**1NSW-63 (sheet 1 of 2)**
**Upper Containment Ventilation**
**Unit 4 Return Line**

LIVSEY & COMPANY, INC.
DONALD C. COOK NUCLEAR PLANT

| CKD. WB | DATE 11-12 | DWG. NO. 1-NSW-63 SH. 1 OF 2 | REV. 1 |

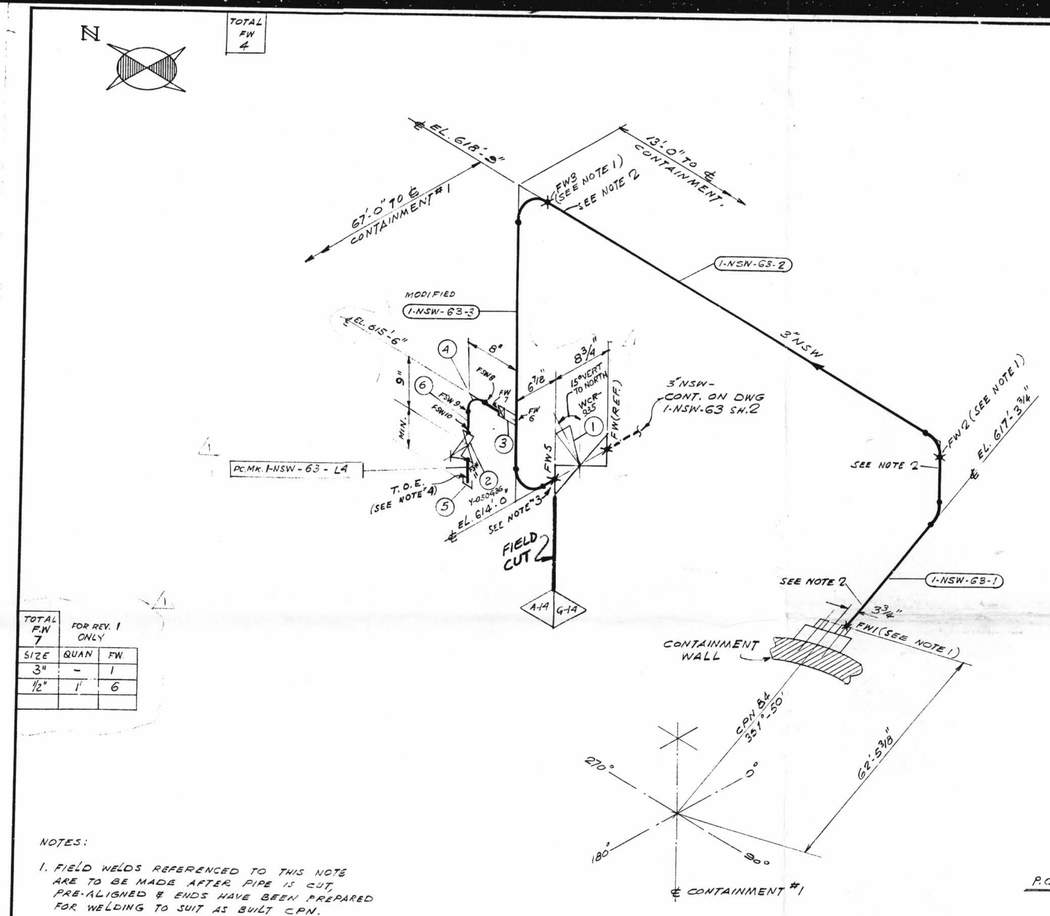
| No | DATE | DR CHK. | DESCRIPTION | REMARKS |
|---|---|---|---|---|
| 1 | 1/13/82 | KA E.J.G. | PER RFC#-DC-12-2549 ADDED DIM'S, NOTES 3&4, PC.MK. L4, FIELD WELD BOX, FW STD 7, FSW 8 THRU 11, ITEM N#'S 2 THRU 6 TO B/M. REVISED ITEM N# 1 B/M. MODIFIED PC.MK. 3. | FIELD ACTION REQ'D. |
